# Modification Recommended Service Note

## Keysight i3070 Series 5 In-Circuit Test System

Figure 2: Screws and screw hole location

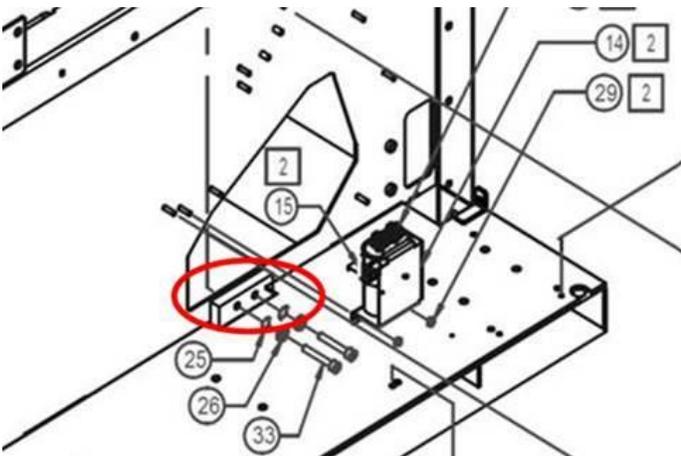
The root cause could be the hole (red circle areas) may be covered by the paint and causing measurement to be “OL”. After the paint was removed from the hole and measurement reading is 0.5 ~ 0.8.

1. Remove the cover near the PDU to access to the screw hole.
2. Remove motor bracket mounting calves.
3. Remove the two screws.
4. Use "File" as tools to remove the paint from the both screw track.
5. Then tighten back both screws.
6. Use multi-meter to ensure connectivity within 0.5 ~ 0.8.
7. Place back the motor bracket mounting calves
